MEETING MINUTES

Jackson Elementary School Modernization
Pasadena Unified School District
Project 0913800.01
District Master Agreement Number T-090615/0015T

MEETING DATE: January 25, 2010

The purpose of the meeting was to present the schematic design color renderings for the Auditorium, Kitchen, Cafeteria, and the redesign of the Administration (see attached color renderings).

Proposed Auditorium View at Platform Area - Option 2

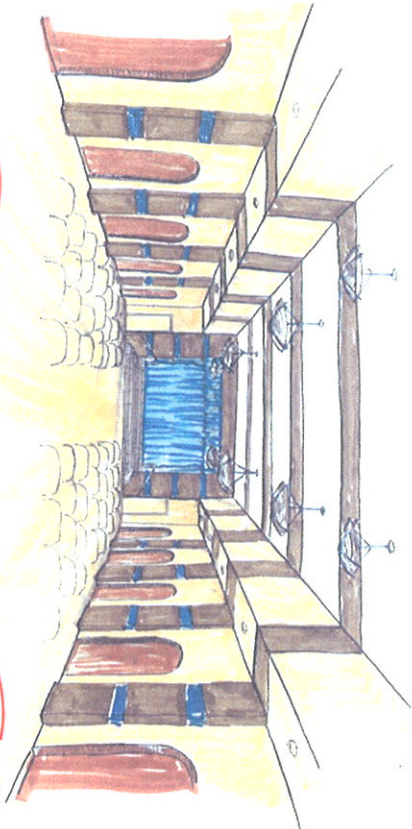
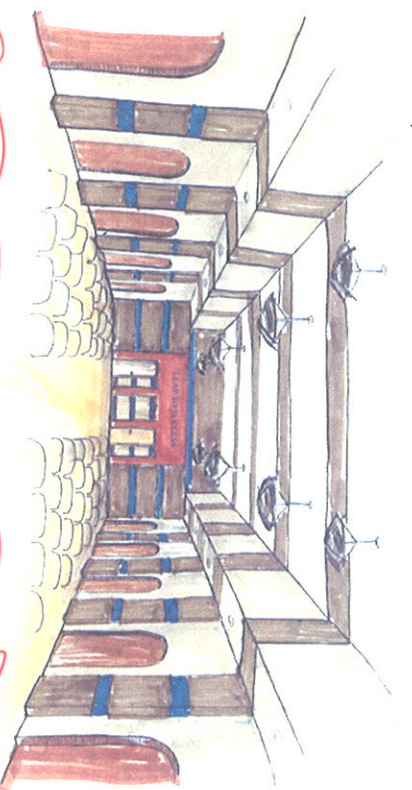
1. Option 2 is preferred by the design committee. The Architect is to further develop this option.
2. The Architect noted the existing Platform area can be enhanced and be the focal point in the space by adding steps in front of the raised platform and providing a framework around it with the school mission statement quoted. The width of steps needs to be 15"-18".

3. The Architect presented the existing stage/platform area as an interchangeable word for design discussions. The Architect to provide storage area to compensate for the loss of storage space below the existing platform.

4. The Architect explained that framing out the proscenium opening and providing the name of the school to provide a sense of identity.
5. The Architect explained that the current lighting in the Auditorium space is inadequate and will be improved during the modernization project.

6. The Architect explained that there is currently an air conditioning system that was installed within the space of the Auditorium and this system will be reorganized and incorporated, and concealed into soffits at both sides of the Auditorium.

7. The Architect explained that there are existing architectural elements such as the brick veneer bandings and pilasters that were incorporated in both Options 1 and 2.

10. The Architect explained that the doors for the main entry to the Auditorium will need to be removed and decreased in size since the code does not require as many doors. The District and Staff would like to maintain the same size doors on either side of the back of the Auditorium if possible. The idea of providing a fixed sand blasted window with grates is an acceptable solution for the center door opening.

Proposed Cafeteria - Option 1

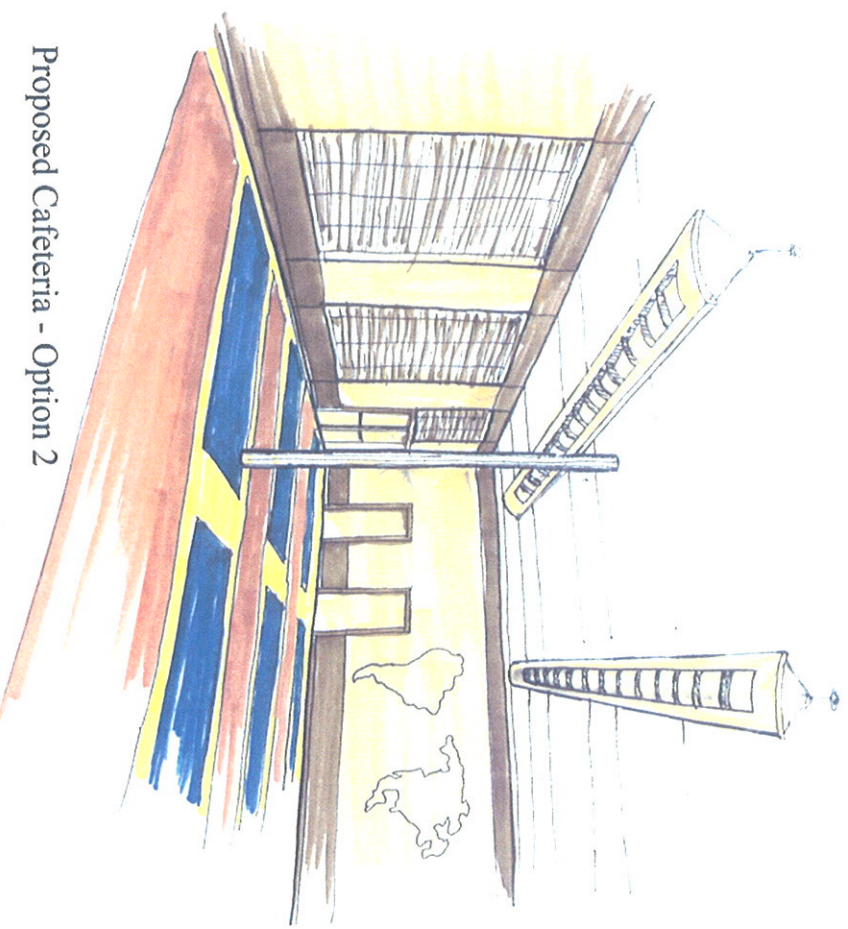
1. Option 1 was preferred by the Design Committee. Include the following items:
 - a. The Architect is to provide color samples and material samples for the staff to review.
 - b. The Cafeteria will have new air conditioning.
 - c. The floor for the space will incorporate Altro flooring.
 - d. The windows will incorporate a wood blind system that is green/eco friendly.
 - e. The walls that currently have the maps can be painted over.
 - f. The District Standard paint is Dunn Edwards. The Architect will bring sample chips for the presentation.
 - g. The walls with painted maps to be tackable wall surface.
2. The Architect presented the modernization of the kitchen and the work that is currently ongoing with the kitchen consultant. The Architect explained that the kitchen modernization work will be incorporated to meet current code requirements.

Proposed Reception Area - Option 2

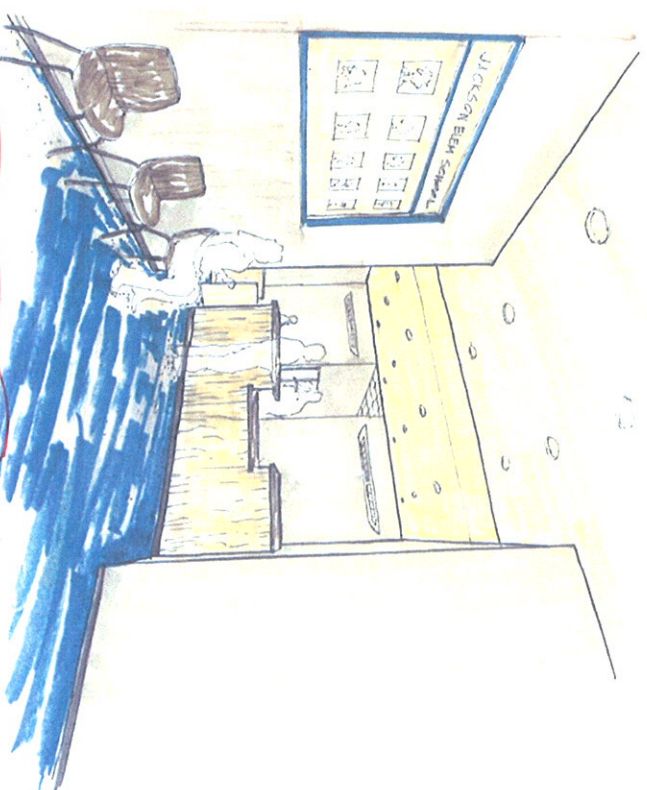
1. Option 2 was preferred by the design committee. The redesign of the Administration office will need to include the following items.
 - a. Provide walk-off mat at entry.

- b. Provide full height glazed lobby door to make the lobby more inviting while allowing improved supervision.
2. The Architect presented both schemes with photos from a previously complete project that illustrate what the reorganization of Administration might look like.
3. The staff requested the reorganization of the student entry to the Administration office be studied further. Consider a secondary student entry to the Administration Office to occur on the north side facing the courtyard.
